Access Compliance Report

Public Rights-of-Way

(Curb Ramps)

Intersection ID: 11256	Main Street: N_IRWIN_AV	Cross Street: W_5TH_ST	Location: E
ADA ID: 0A4F73CF0FD1	Ramp Type: Perp	Initial Pass/Fail: Fail	Overall Compliance: No
Severity Score: 12.5			
Codes/Mitigation Info/Possible Solution		Field Measurements/Component Compliance

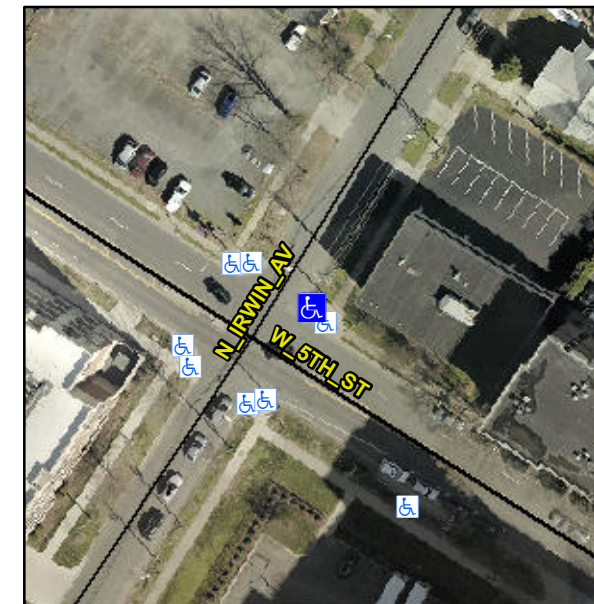
Not Found, R304.5.3

Compliance	Description	Data	Compliance	Description	Data
N/A	Ramp Length (in)	85.0	Yes	Ramp Slope (%)	5.3
Yes	Ramp Width (in)	49.0	No	Ramp XSlope (%)	6.5
N/A	Flare Type LT	N/A	N/A	Flare Type RT	N/A
N/A	Flare Slope LT (%)	N/A	N/A	Flare Slope RT (%)	N/A
N/A	Flare Traversable LT?	N/A	N/A	Flare Traversable RT?	N/A
N/A	Landing Length (in)	N/A	N/A	DWS Provided?	N/A
N/A	Landing Width (in)	N/A	N/A	DWS Contrast?	N/A
N/A	Landing Slope (%)	N/A	N/A	DWS Length (in)	N/A
N/A	Landing X Slope (%)	N/A	N/A	DWS Full Width?	N/A
N/A	Landing Curb? (Y/N)	N/A	N/A	DWS Offset (in)	N/A
N/A	Shared Landing?	N/A			
N/A	Gutter Ponding?	N/A	N/A	Gutter Slope (%)	N/A
N/A	Gutter Lip Ht (in)	N/A	N/A	Gutter X Slope (%)	N/A
N/A	Painted X Walk1?	No	N/A	Painted X Walk2?	N/A
	X Walk 1 Direction	To NW		X Walk 2 Direction	N/A
N/A	X Walk 1 Width (in)	N/A	N/A	X Walk 2 Width (in)	N/A
	X Walk 1 Slope (%)	0.5		X Walk 2 Slope (%)	N/A
	X Walk 1 X Slope (%)	2.9		X Walk 2 X Slope (%)	N/A

Remove & Replace Entire Ramp.
